Product Announcement

The Control Board Evolution BOARD 070M

Manaras-Opera Presents The Next Generation of Control Board

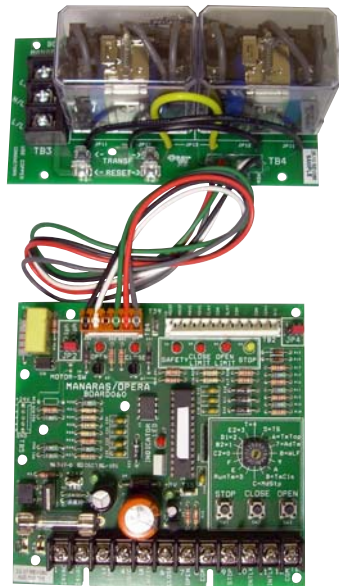
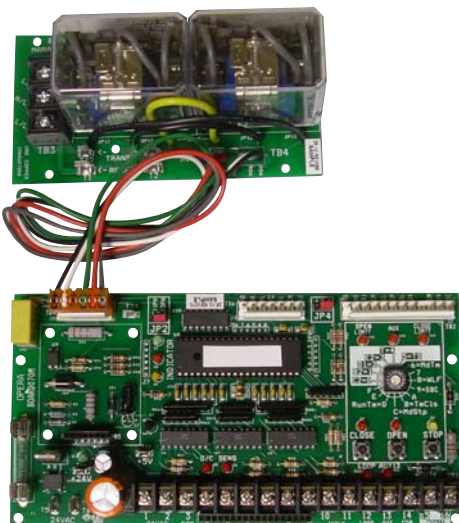
Manaras-Opera is pleased to announce the product launch of its latest Electronic Control Board: **BOARD 070M**. It's the natural evolution from the extremely successful and reliable **BOARD 060**.

BOARD 070M provides the same key functions that you've come to expect from **BOARD 060**, plus several enhancements.

- **Compliance to ANSI / UL325: 2010 safety standards. Monitored input for external protection devices.**
- Improved readability of rotary selection switch dial.
- Increased diagnostic LED feedback.
- New independent loop input terminal.
- Next generation optional radio receiver plug-in.
- Extra auxiliary terminal (contact factory for further details).
- Design improves robustness for adverse field conditions.
- Ready to receive optional universal auxiliary output module (a.k.a. Warning Light Module).
- Timer-to-close can be activated/deactivated by the user from floor level using the 3-button station.
- Single-button control (SBC) field activated/deactivated.
- Improved access to power and control terminal strips.
- Motor direction re-wiring in seconds.
- Plus many more...
- Please consult factory for pricing details.
